## **AGENDA**

### **CALL TO ORDER**

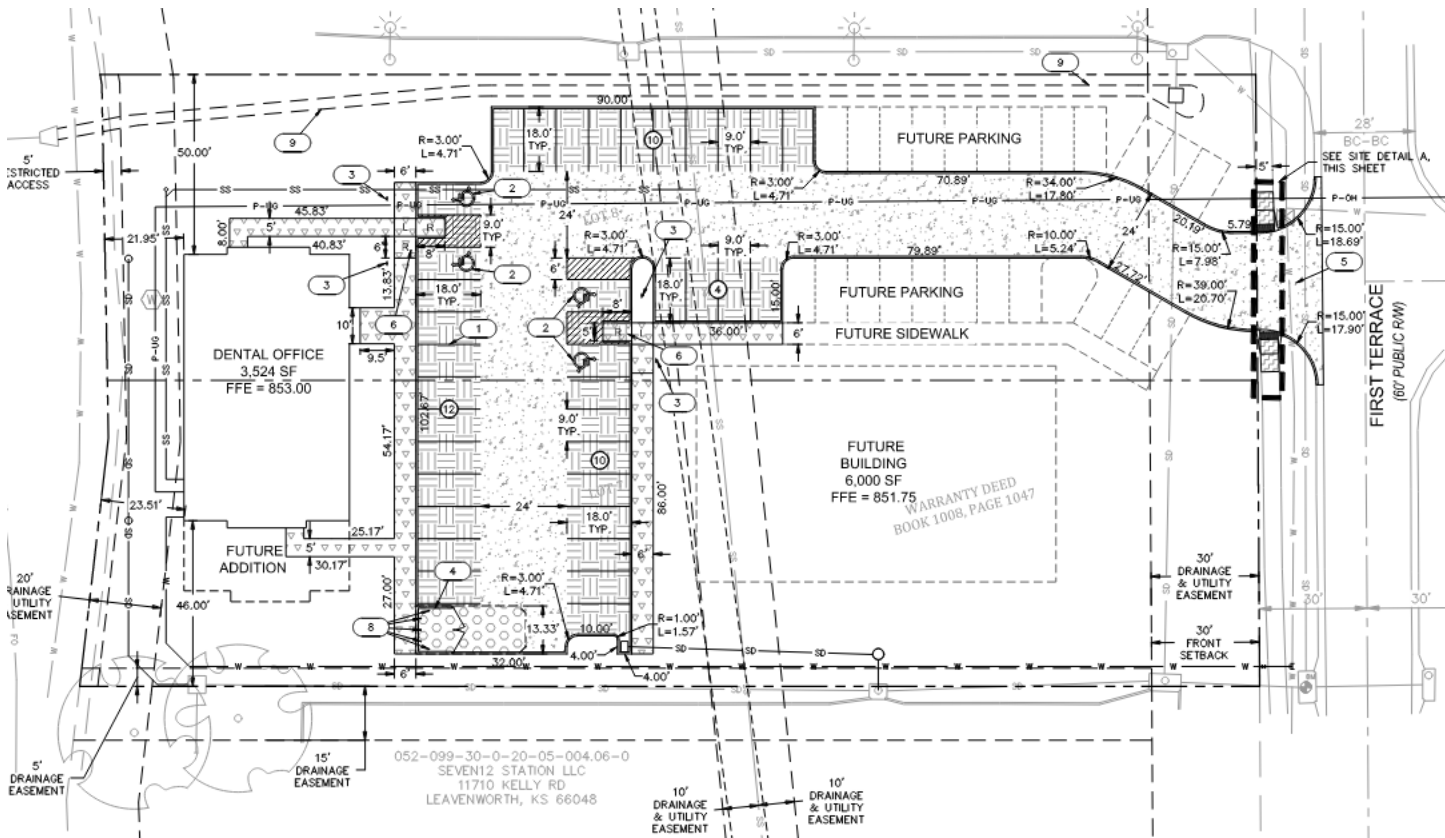
The Wastewater Director has reviewed the site plan for conformance with City requirements and found items of discussion as shown on the attached marked up Site Plan. There is a section of existing sewer line that runs under where the proposed future building will be located which will need to be relocated at some point.
